## &lt;Addendum #3&gt;

**PROJECT #: EL-0006-C01**

**DESCRIPTION: Elizabeth Academic High School**

SCALE: (N) 1/8" = 1'

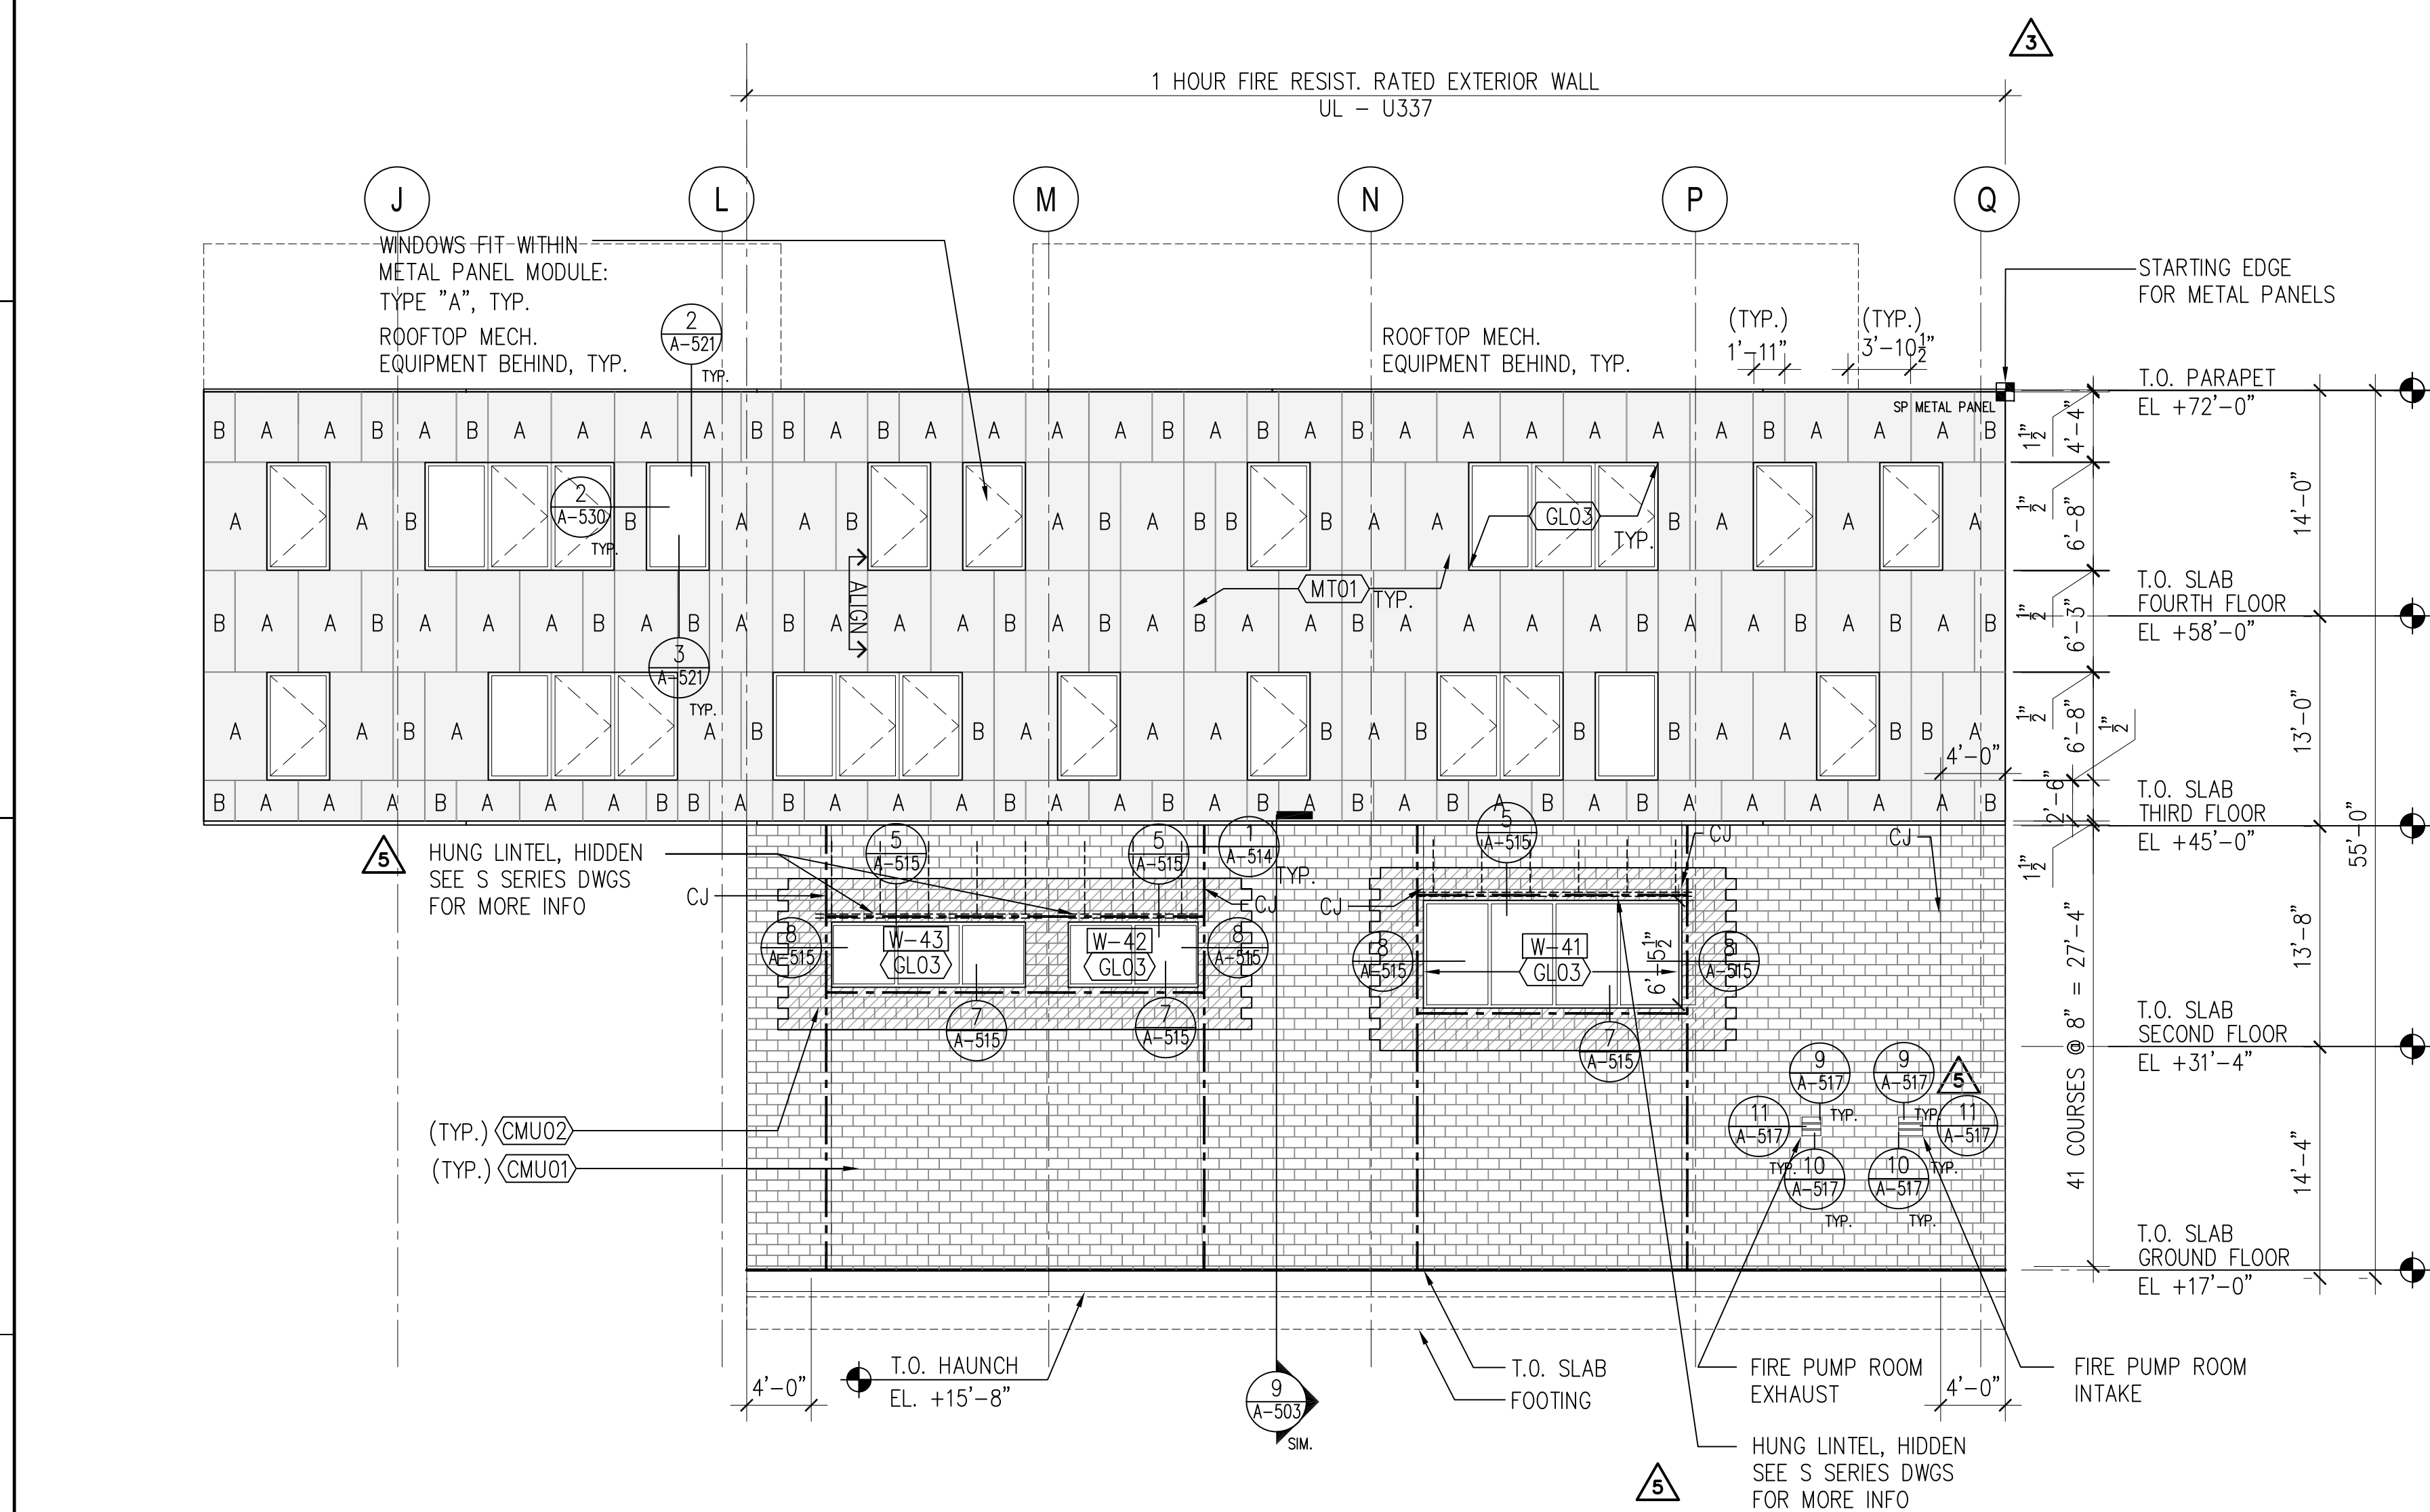
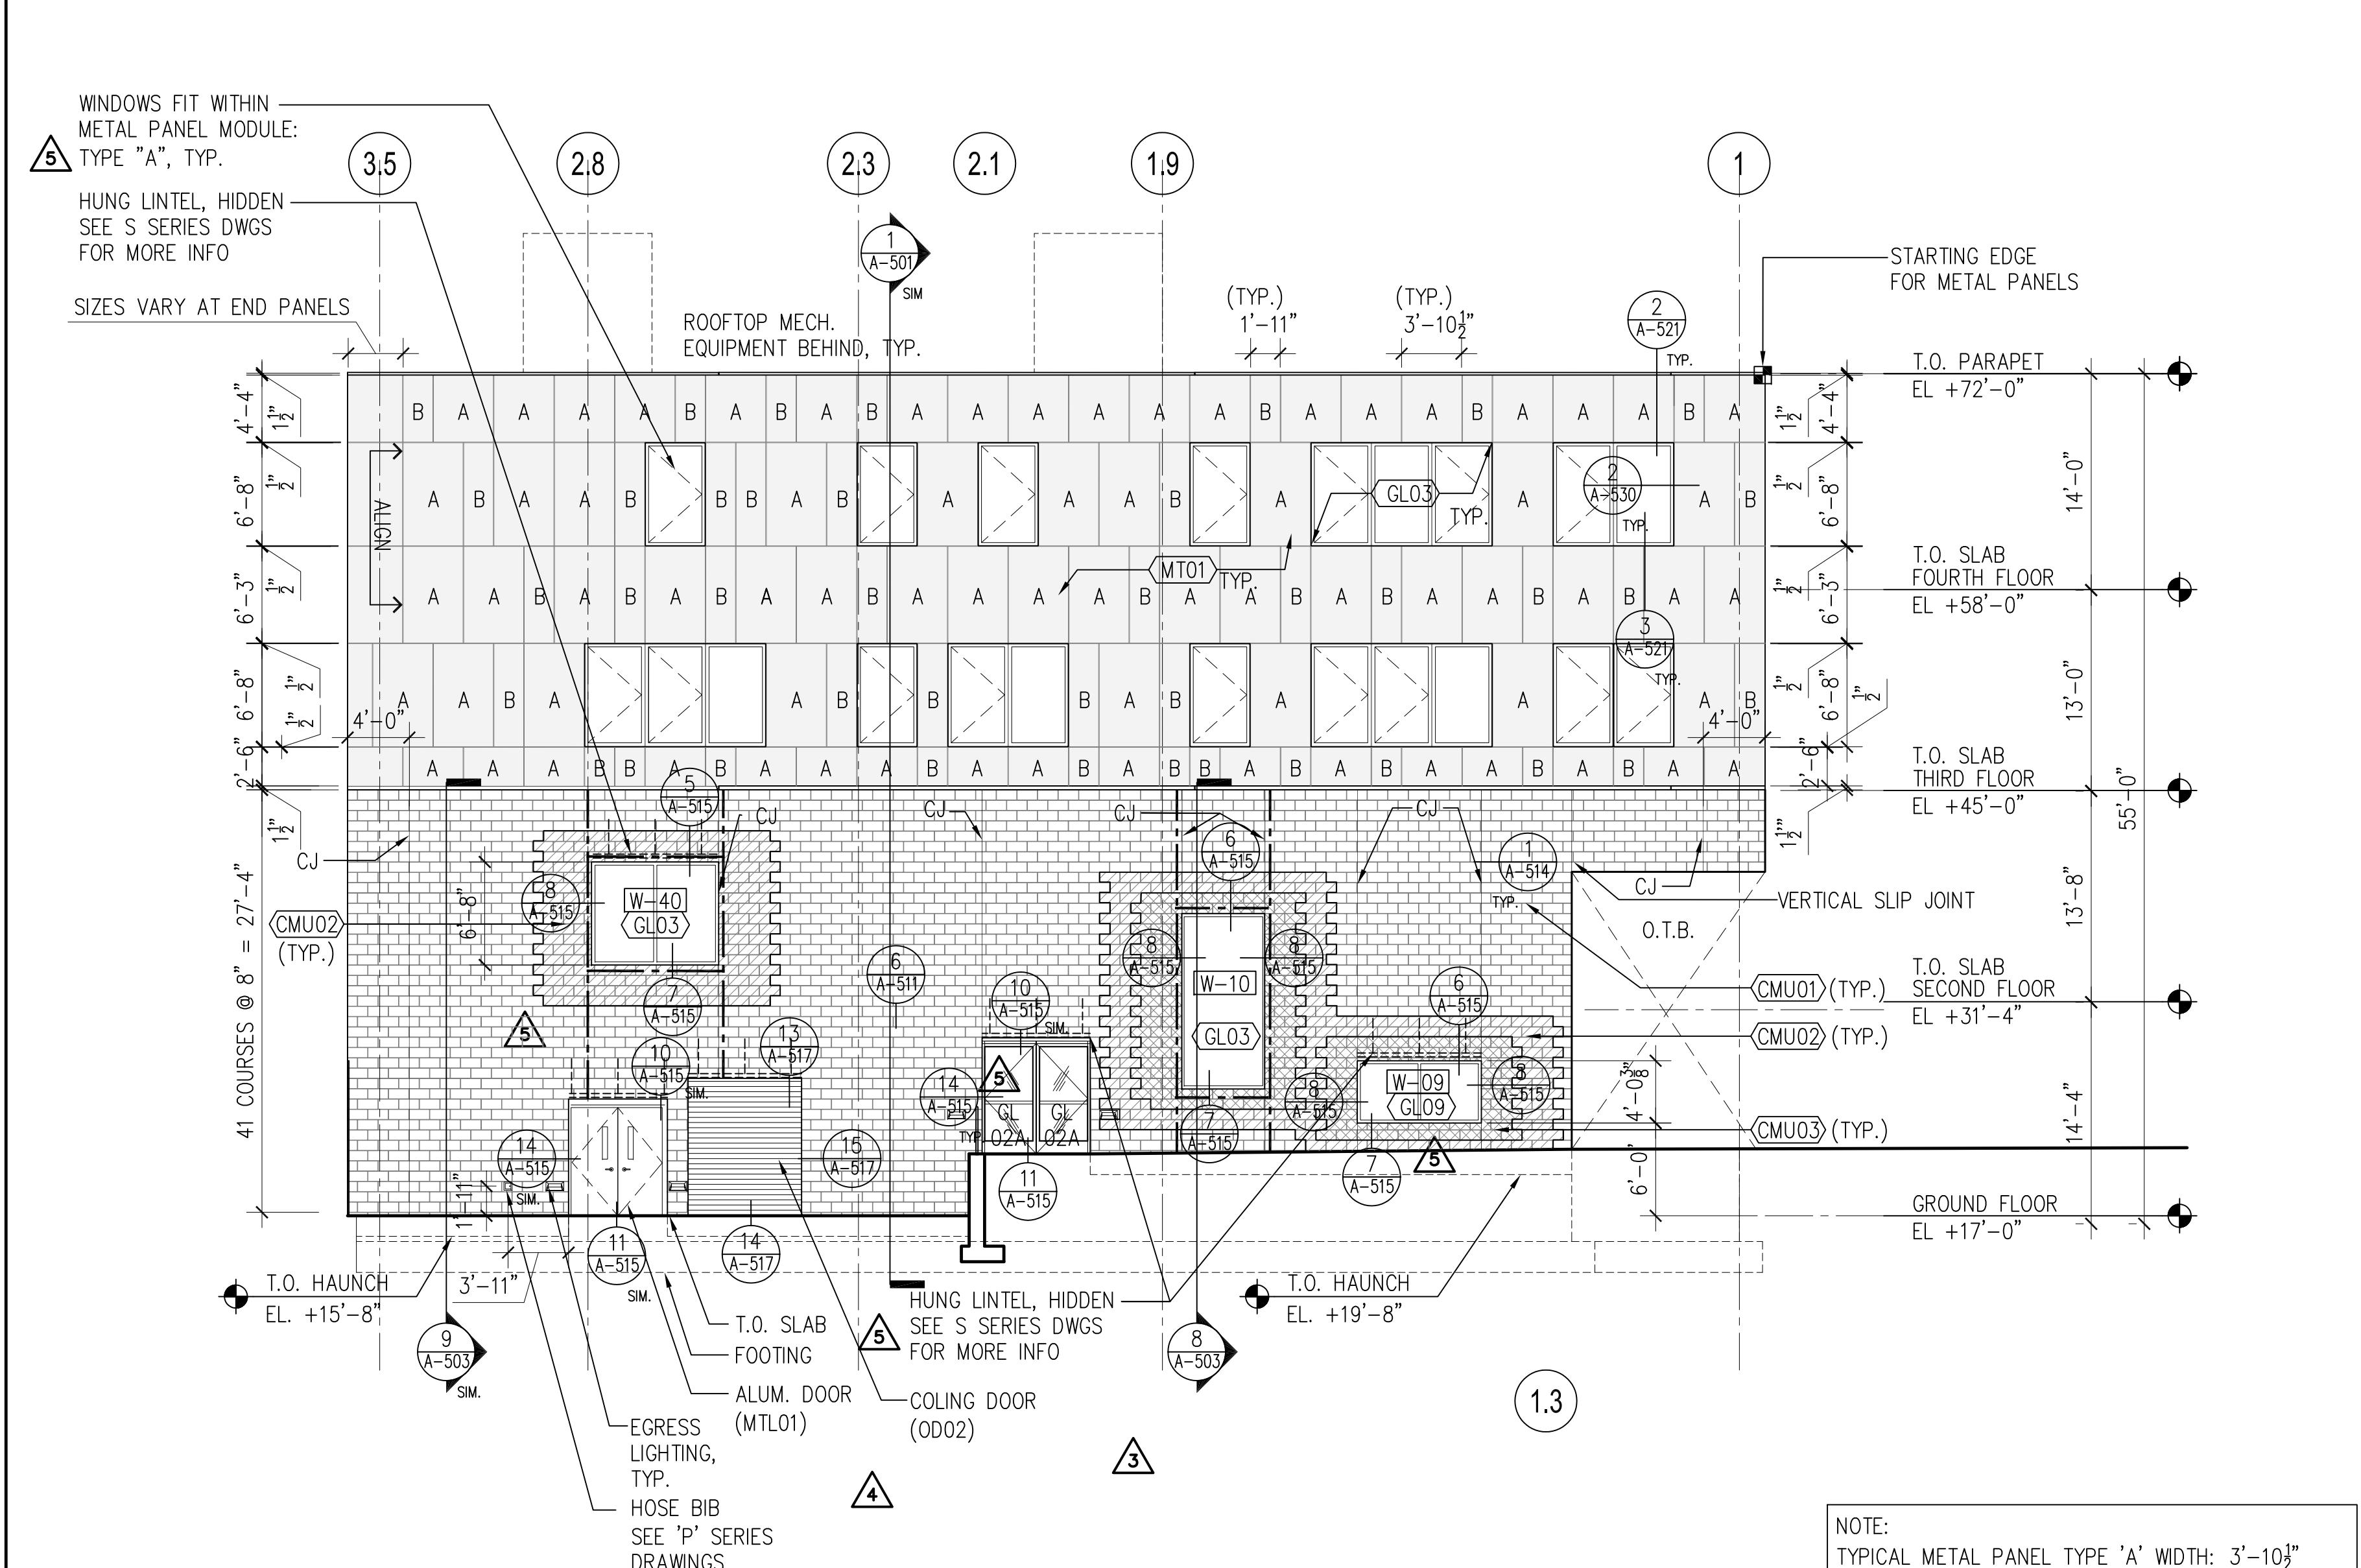
**A.16 Question:** With reference to frame elevation "W-11" (1/A-204), will this frame remain a window as per the exterior window schedule? The detail call outs indicate a combination of stacked window wall and curtain wall. Please advise which system is to be utilized.

**Answer:** The frame shown is a storefront system.

9 ELEVATION AT LOWER ROOF  
SCALE: (N) 1/8" = 1'

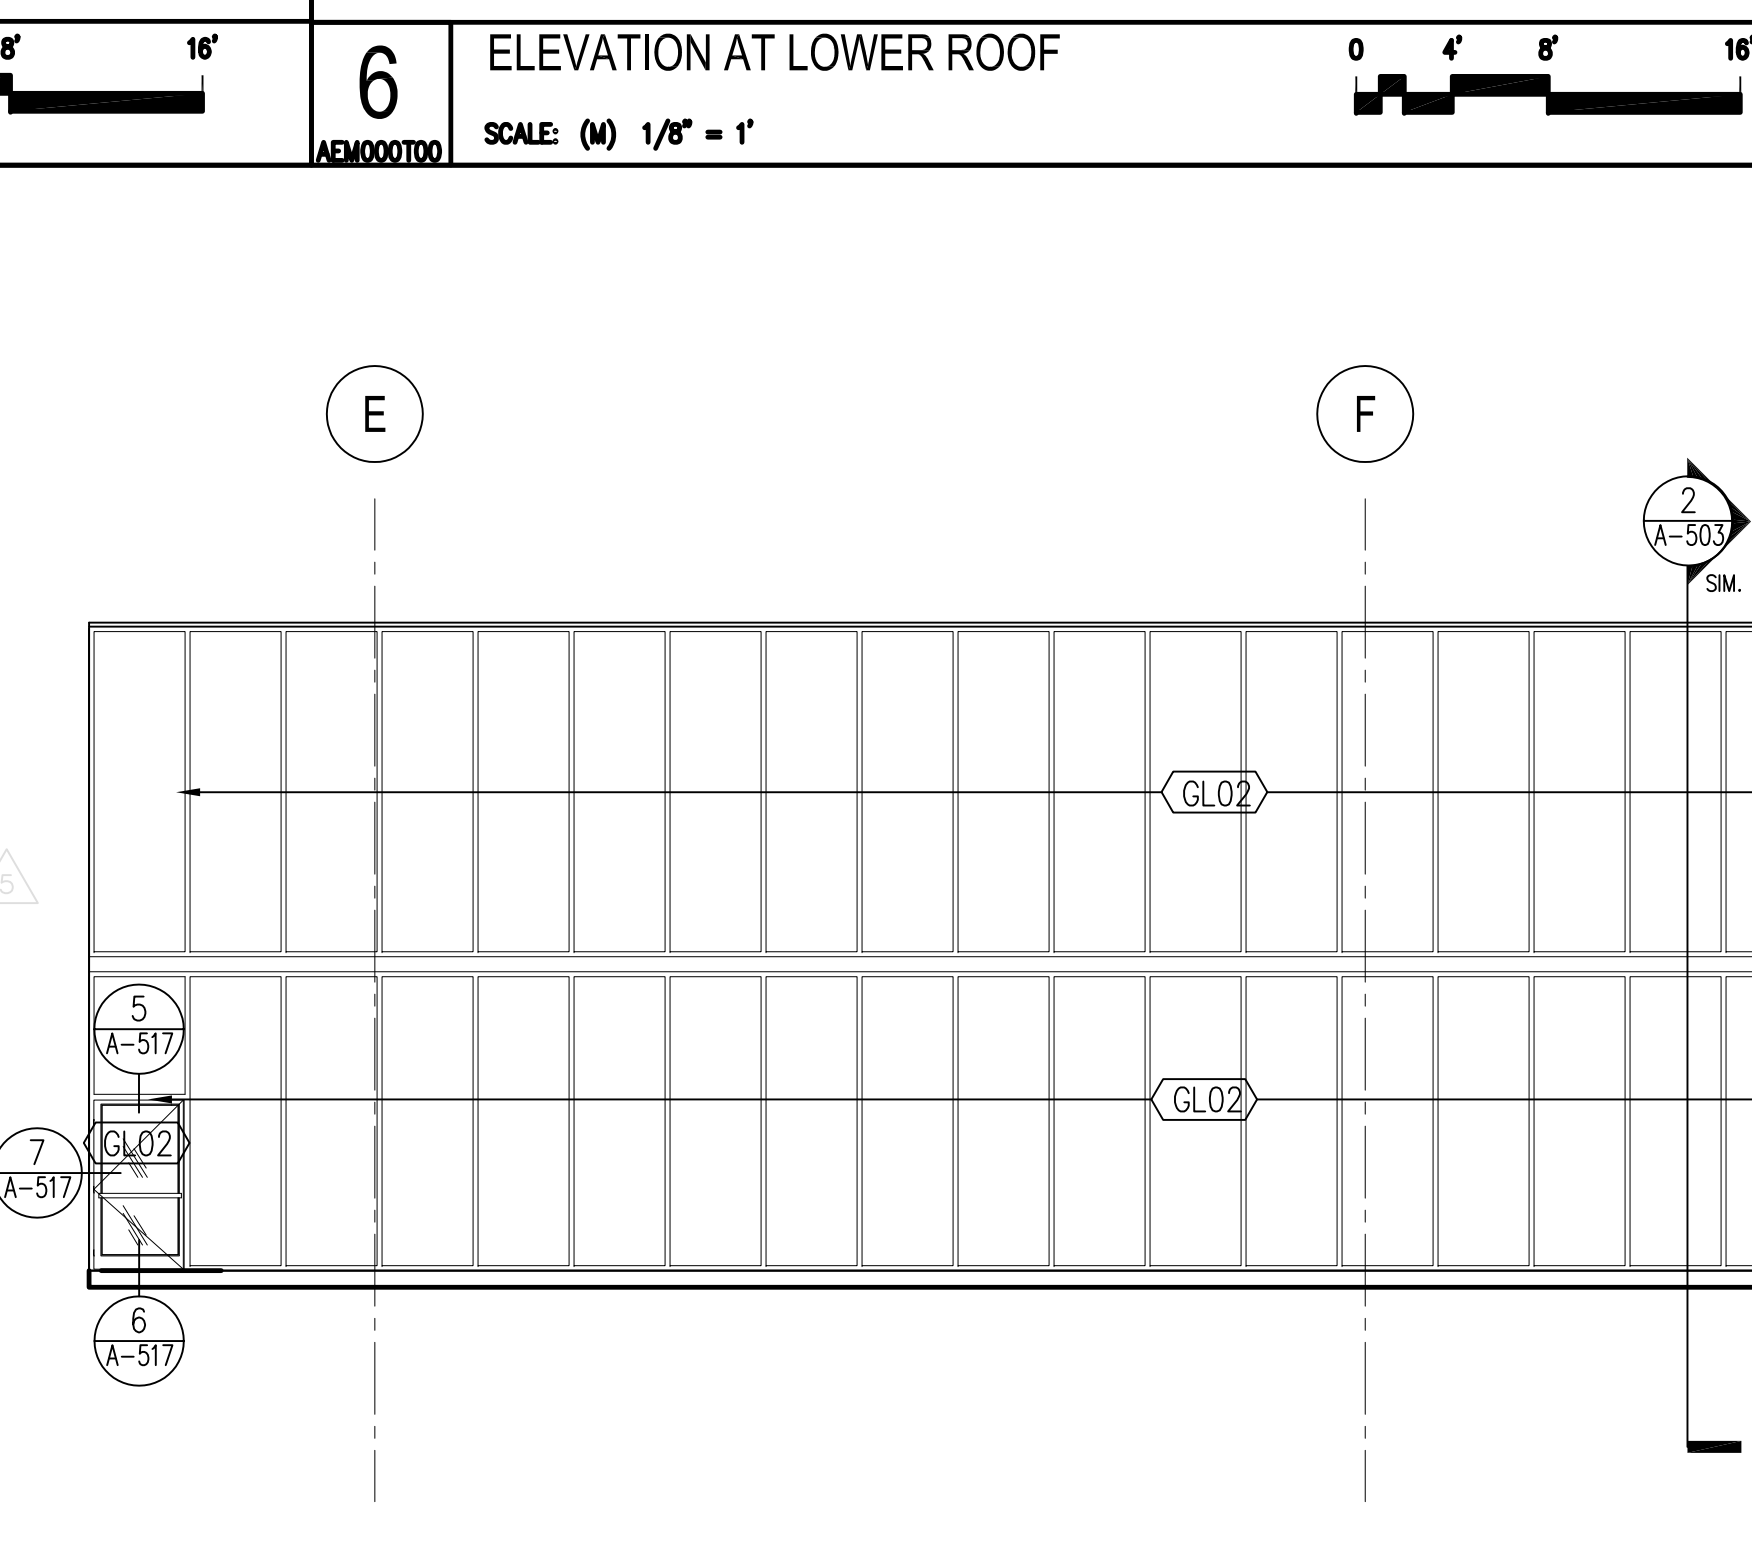
**A.20 Question:** With regards to elevation 9/ A-206, it differs from what is shown on the floor plan 2/A-340. Please advise which is shown correctly.

**Answer:** Plan (2/A-340) is correct. Elevation (9/A-206) will be revised accordingly in an upcoming addendum.
